**Maine Maritime Academy  
Castine, Maine**

**Pier Upgrades and Waterfront Improvements Project  
March 1, 2024  
ADDENDUM NO. 3**

**1 PROFILE - TRENCH AREA A**  
SCALE: 3/8" = 1'-0"

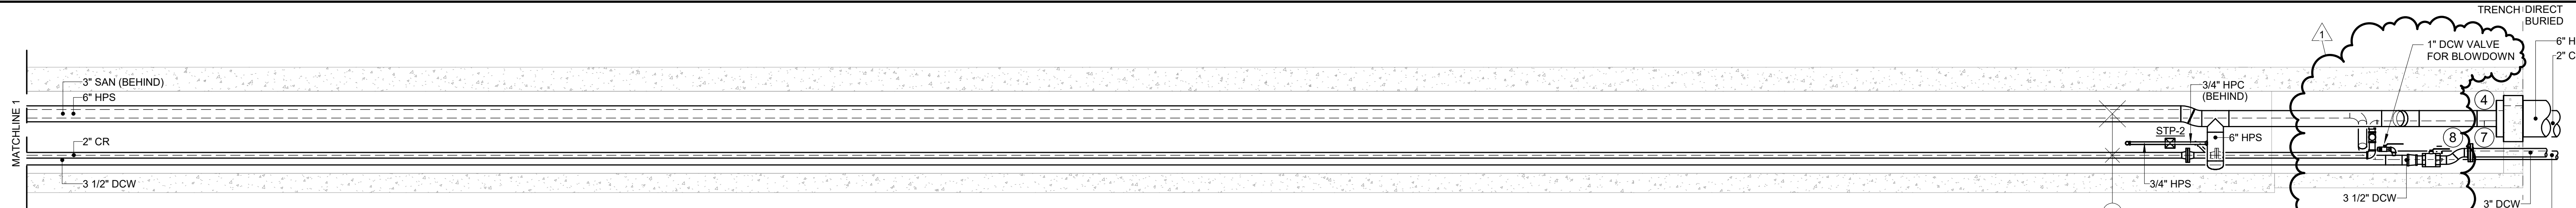
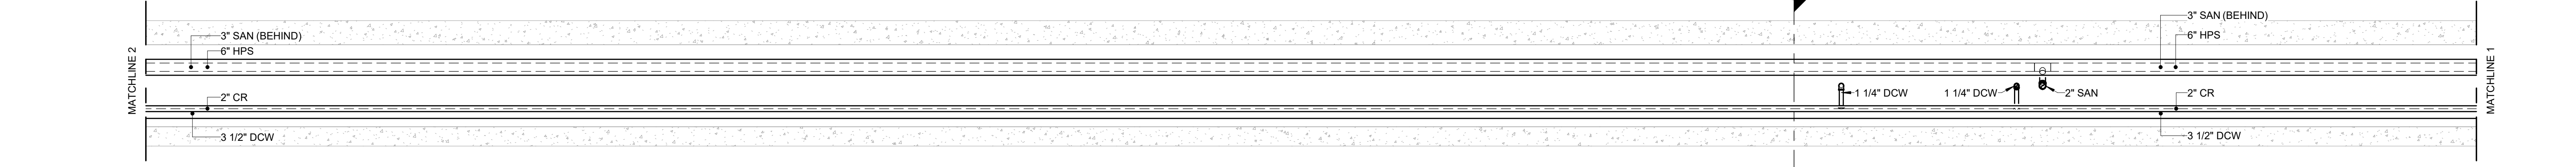
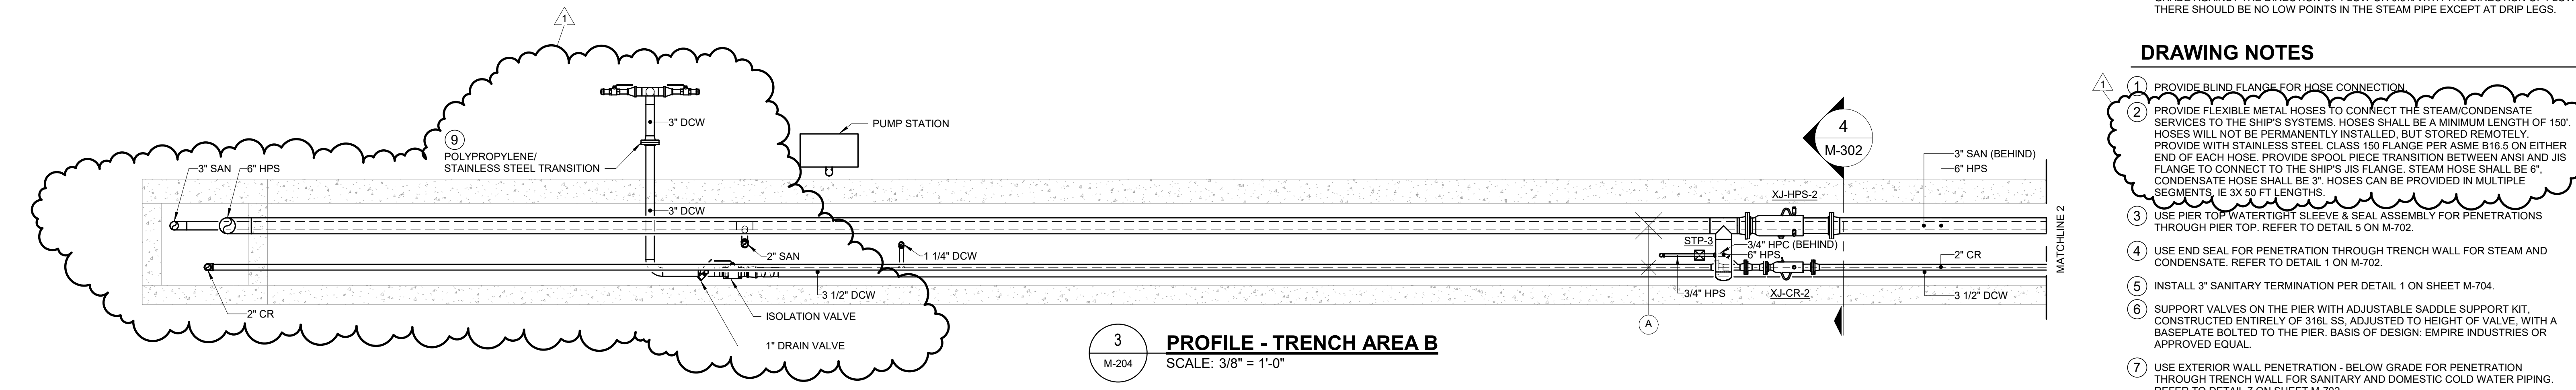
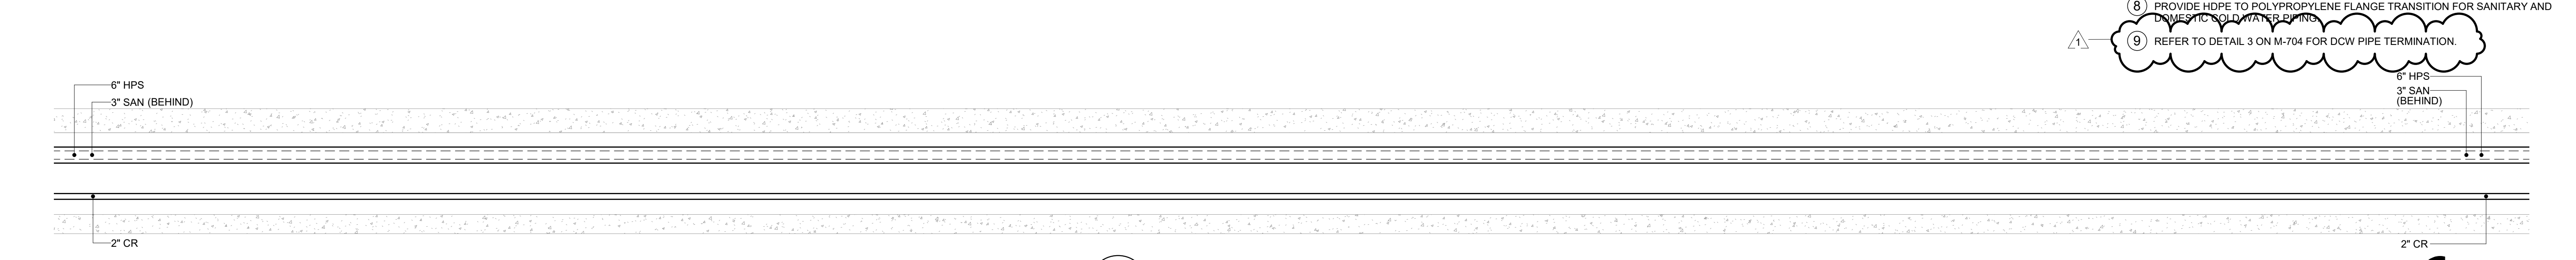
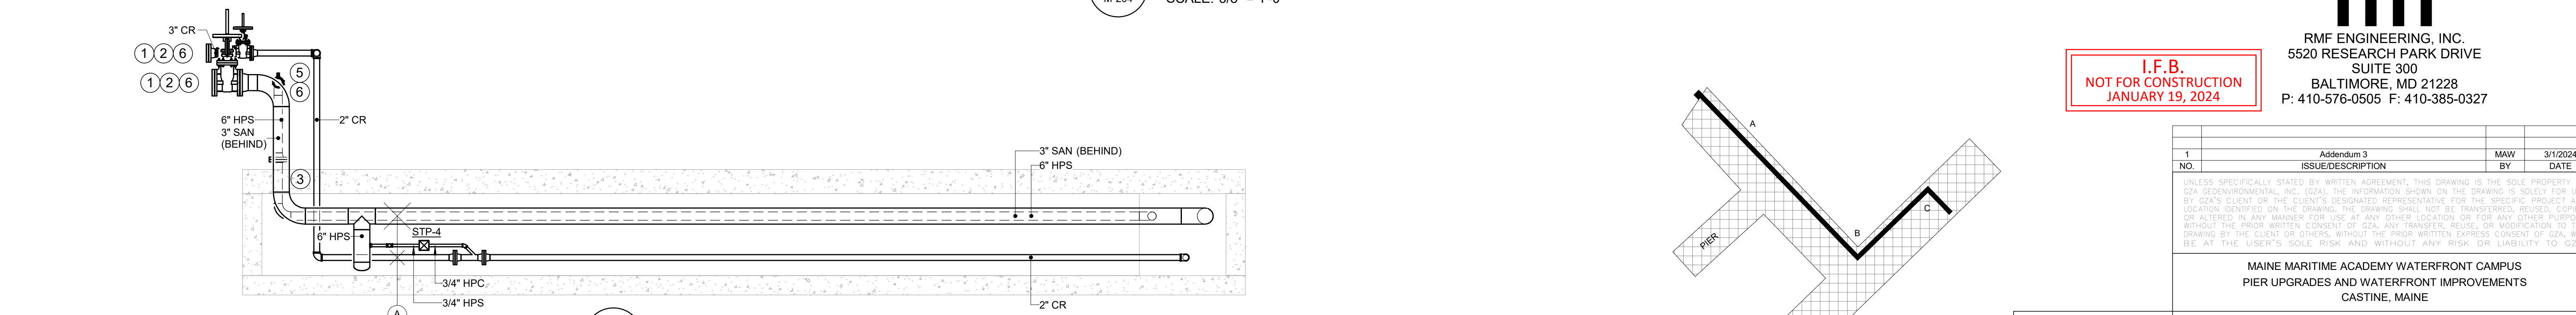
- a. Added (2) 3” ball valve, and (2) 1” blowdown/drain valves to the DCW line in the utility trench.
  - b. Showed the new location for the DCW pipe termination for the ship’s connections.

**SHEET E-201 NUMBERED ELECTRICAL NOTES**

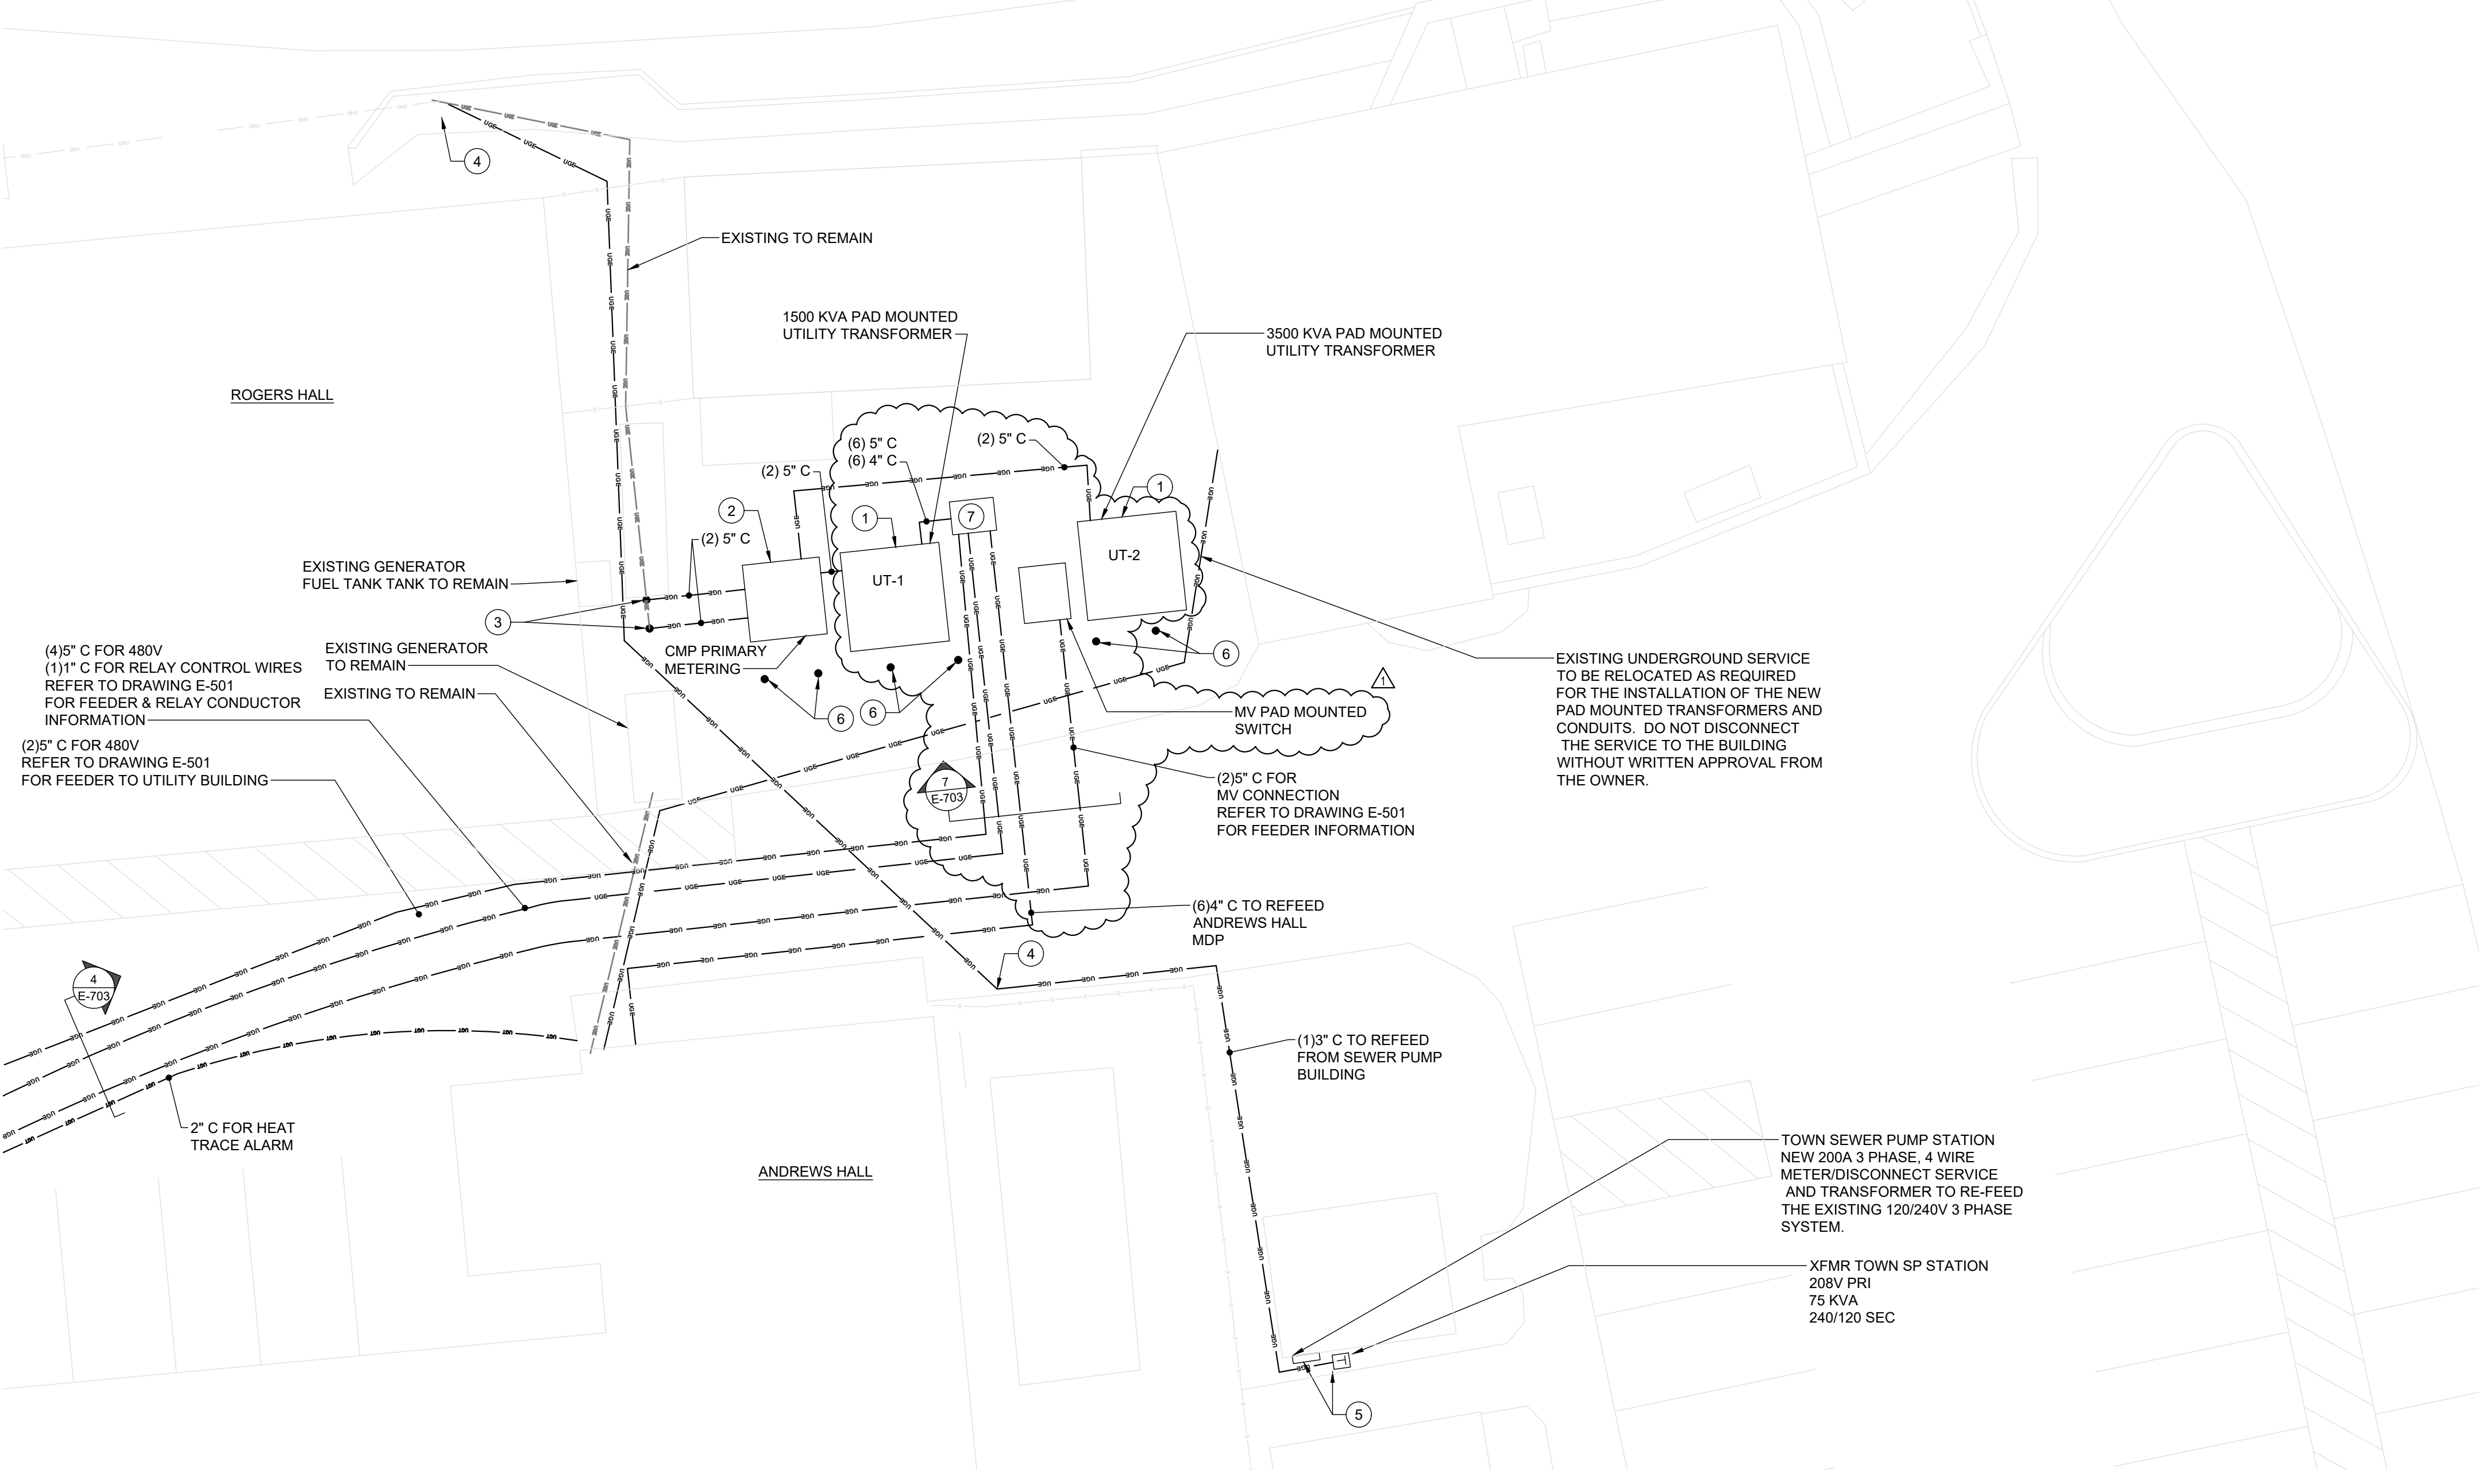
25. E-201 Electrical Site Part Plan A
  - a. Updated layout of the exterior electrical equipment.
  - b. Added medium voltage pad mounted switch adjacent to UT-2 for the 6.6kV ship feed.

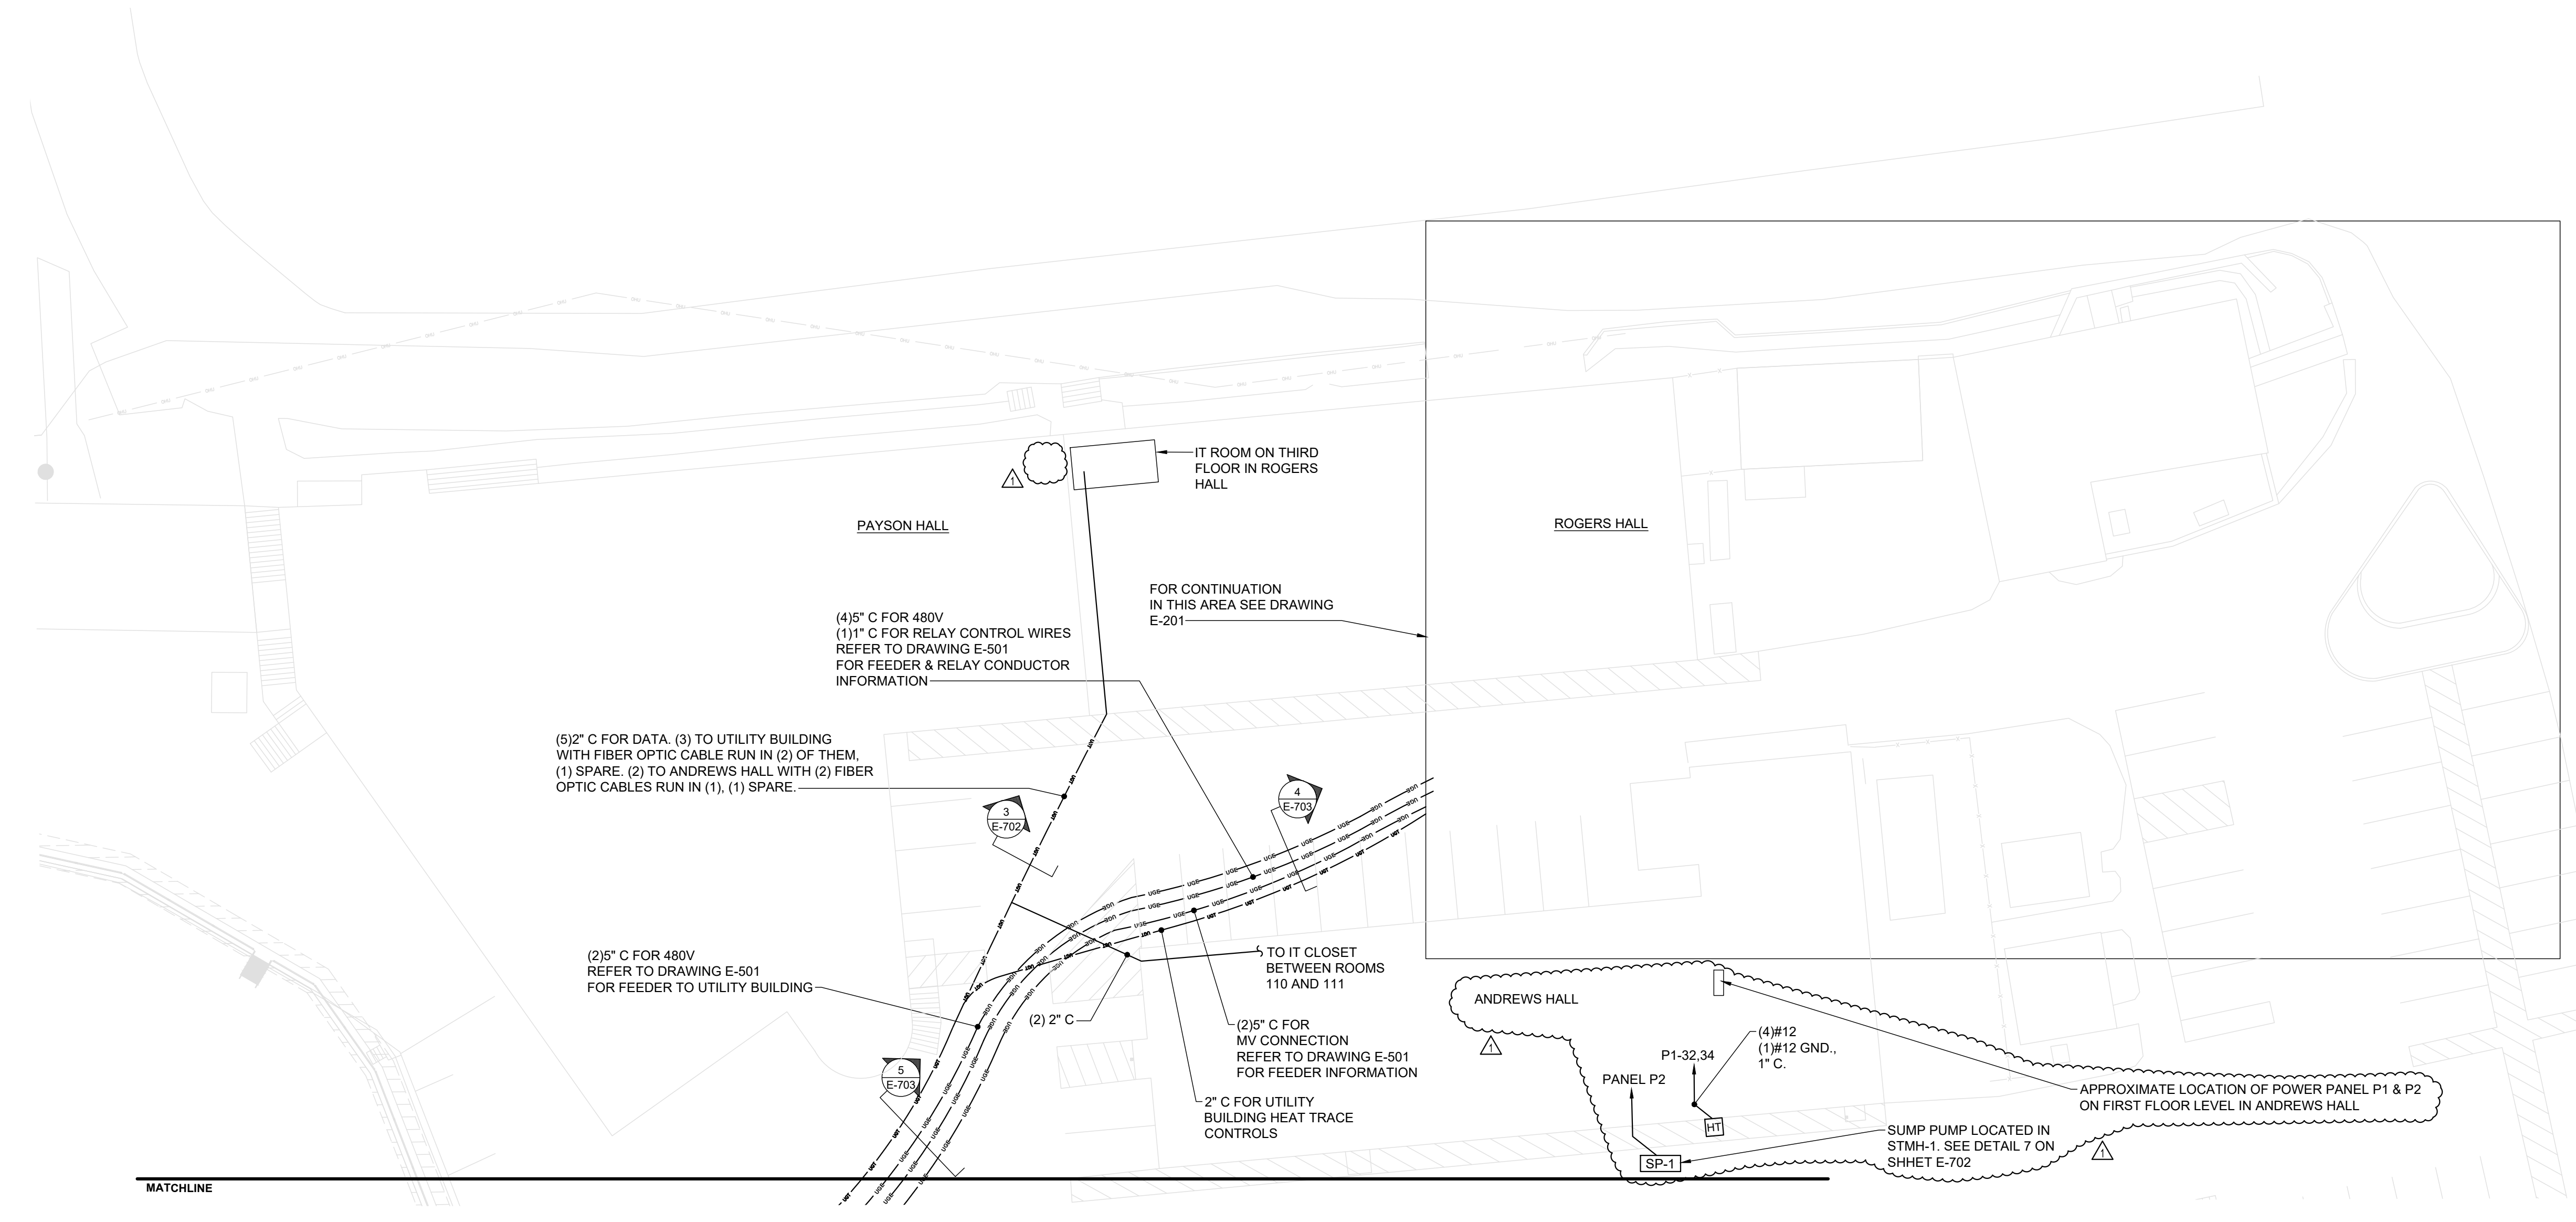
26. E-202 Electrical Site Part Plan B
  - a. Added sump pump connection. Sump pump located in steam manhole STMH-01.
  - b. Added approximate location of Power Panels P1 and P2 within Andrews Hall.

- c. Removed plan note symbol "1".
- 27. E-203 Electrical Pier Part Plan A
  - a. Revised description of NSMV 480V and 6.6kV SPO connection gear on pier.
